Groundwater Transfer Review Summary Form

Transfer/PA # T- 14655

Application: T-14655

Applicant Name: Andrew and Karen VanderPlaat

Figure 1. Map of Authorized POA, Proposed APOA, and nearest groundwater right POAs

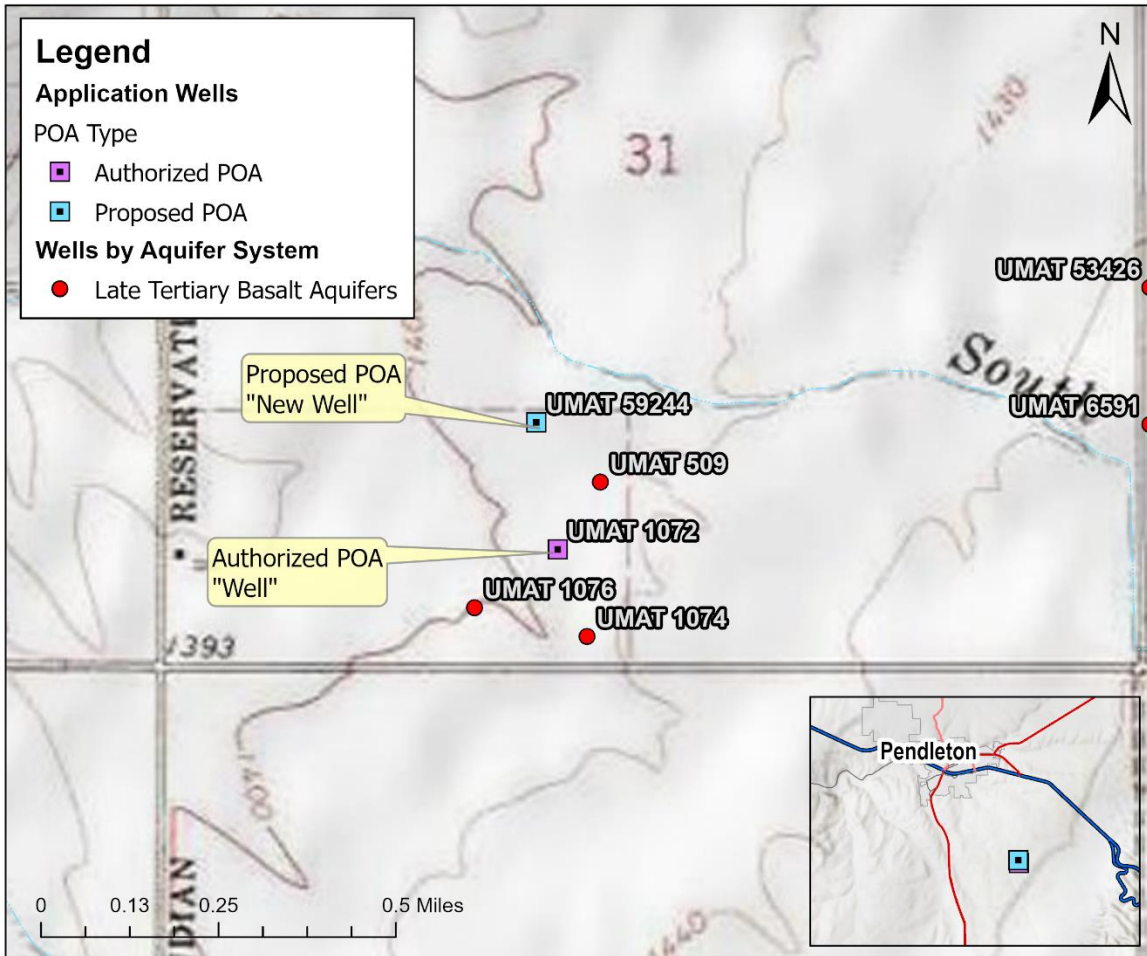
1. Basic description of the changes proposed in this transfer: The application proposes to change the point of appropriation (POA) for water right certificate 55841. The applicant subdivided their original tax lot (tax lot 1400), and drilled the “New Well” (UMAT 59244) on tax lot 300 to supply domestic and irrigation water for 5.43 acres. The application proposes splitting the 0.13 cfs rate allowed in certificate 55841 between the original Well (UMAT 1072) and the New Well (UMAT 59244). Tax lot 1400 will have 0.062 cfs while tax lot 300 will have the remaining 0.068 cfs.

2. Will the proposed POA develop the same aquifer (source) as the existing authorized POA?
 Yes No Comments: Authorized and proposed POAs produce from water-bearing zones in the Columbia River Basalt Group aquifer system. Within the CRBG, most water occurs in confined aquifers that occupy thin rubble zones (interflow zones) at the contacts between lava flows. The interior of a basalt flow generally has low porosity and permeability and acts as a confining bed. This geometry generally produces a stack of thin aquifers (interflow zones) separated by thick confining beds (flow interiors). The low permeability of the basalt flow interiors probably limits the natural vertical connection between overlying aquifers.
